# INNER WEST COUNCIL

## DEVELOPMENT ASSESSMENT REPORT

<b>Application No.</b>	DA201500632.03
<b>Address</b>	819 New Canterbury Road, Dulwich Hill
<b>Proposal</b>	Modify Determination No.201500632.02 under Section 4.55 of the Environmental Planning and Assessment Act to construct an additional storey above Buildings A and B, resulting in a 5 storey mixed use development.
<b>Date of Lodgement</b>	28 June 2019
<b>Applicant</b>	Mars City Pty Ltd C/o Nordon Jago Architects
<b>Owner</b>	North Sol Pty Ltd
<b>Number of Submissions</b>	One
<b>Value of works</b>	\$5,614,459.00
<b>Reason for determination at Planning Panel</b>	Departure to development standards that exceeds 10% Sensitive development
<b>Main Issues</b>	<ul style="list-style-type: none"> <li>• Visual bulk</li> <li>• Streetscape impacts</li> <li>• Non-compliance with height and FSR development standards</li> </ul>
<b>Recommendation</b>	Approval with Conditions
<b>Attachment A</b>	Recommended conditions of consent

Figure 1: Non-compliance with ADG for rear setback the original submission

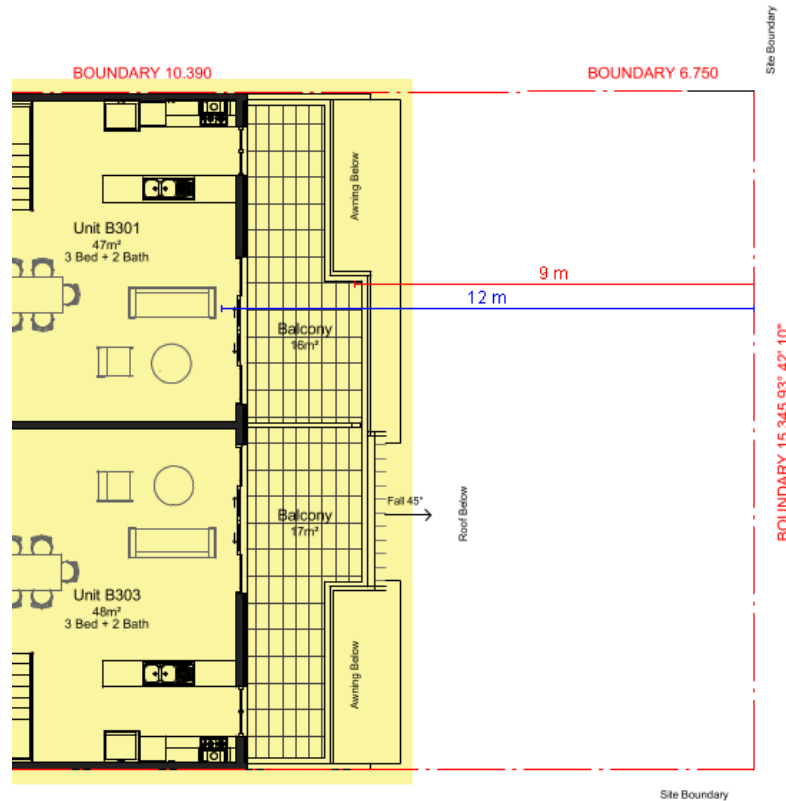
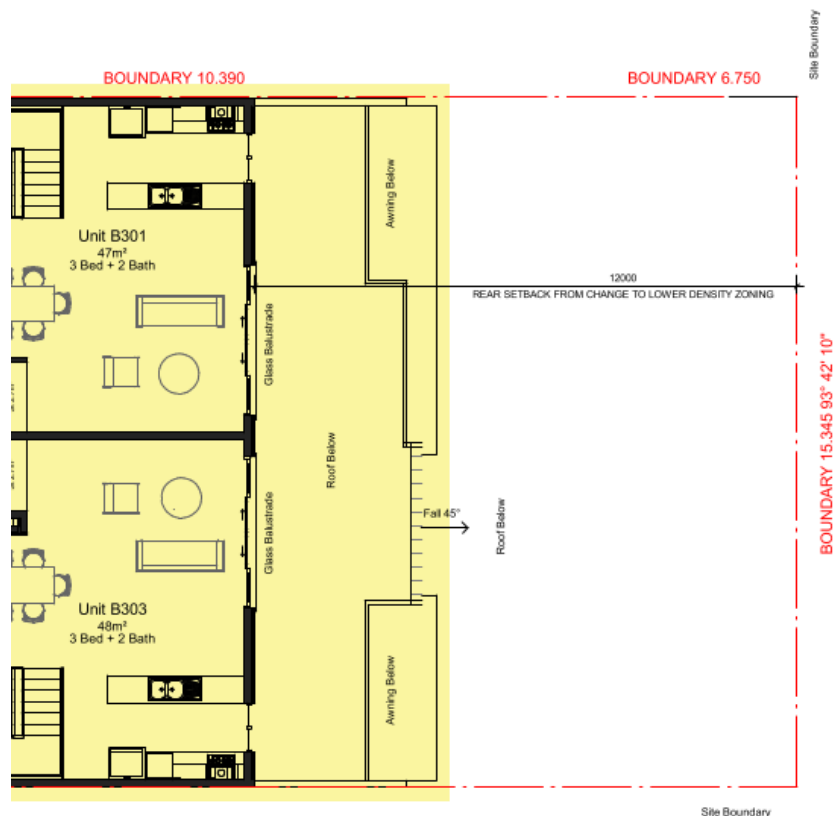
The balconies of the originally proposed fifth floor provided a setback of approximately 8.6m. It is noted that the adjoining property to the rear is zoned R1 General Residential which permits residential flat building and multi dwelling housing but has a low density FSR of 0.6:1 and as a result the requirement is to provide an additional 3m to the above figures. Given that the rear use of the property is that of a dwelling house and a walk up RFB and the adjoining properties fifth storey is not setback the required distance by the ADG inclusive of the additional 3m. After being advised of the need to condition the proposal to compliance with the ADG, the applicant elected to submit amended plans to make the proposal comply with the ADG requirements.

**Figure 4: Amended submission that is compliant with the ADG for rear setback**

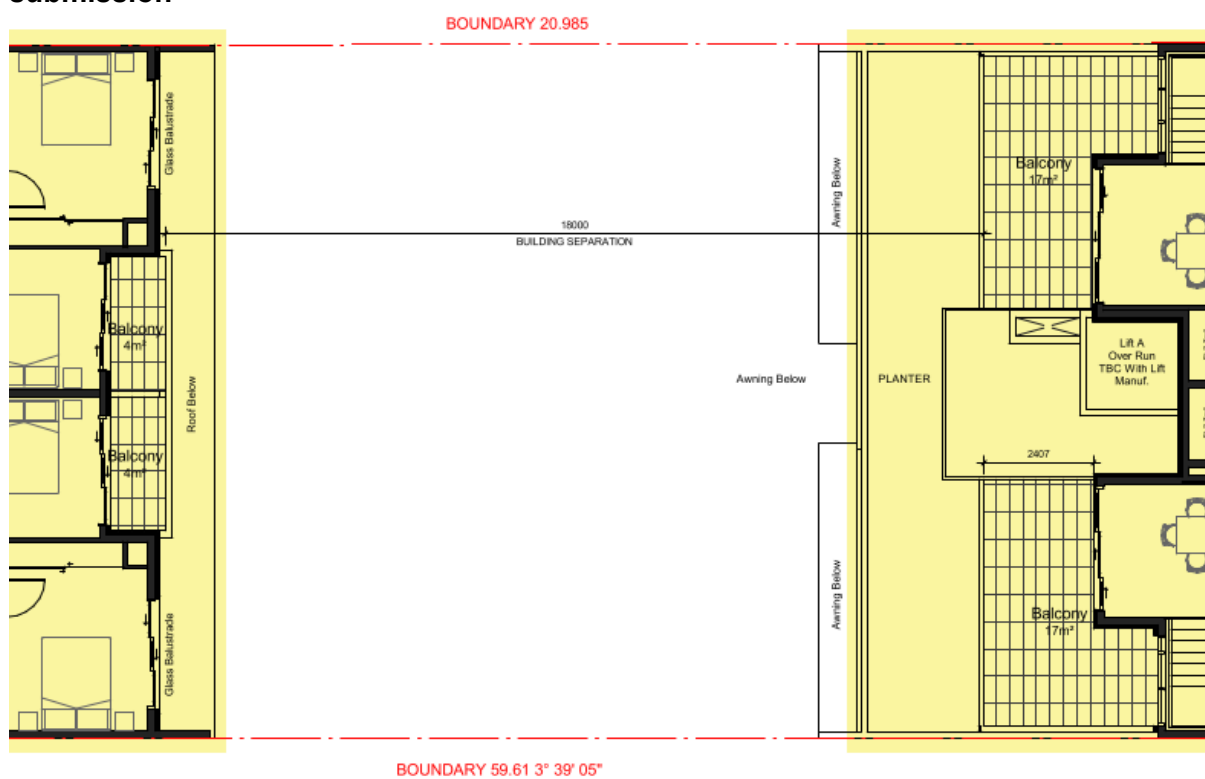
The originally proposed fifth floor also failed to meet the requirements for separation between balconies. The intent of these controls is to increase the level of separation as the building height increases. In this case the development has largely followed the existing building separation. Noting that the proposal exceeds the FSR and height development standards the controls for separation of building represent an important constraint on the extent of the development and assist in preserving the amenity of the future residents. After being advised of the need to condition the proposal to compliance with the ADG, the applicant elected to submit amended plans to make the proposal comply with the ADG requirements.

**Figure 6: Overshadowing impacts at 3PM to adjoining north facing balconies**

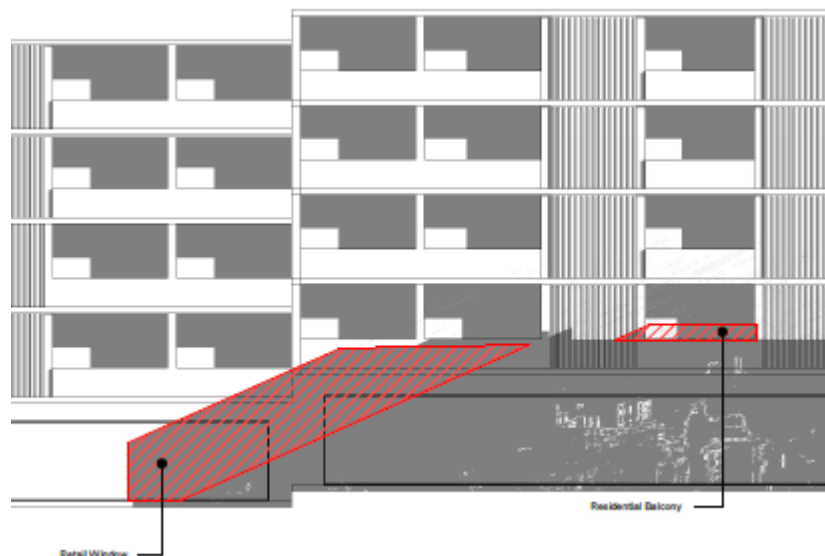
Issue: Overshadowing

Comment: The level of overshadowing caused by the proposed modification is consistent with the requirements of C2 within Part 2.7.3 of the Marrickville DCP 2011, which are the applicable development controls. The overshadowing is largely to the rear of the retail level with overshadowing only occurring at 3pm for a small section of one balcony, which is well within the parameters of the relevant controls within Marrickville DCP 2011.
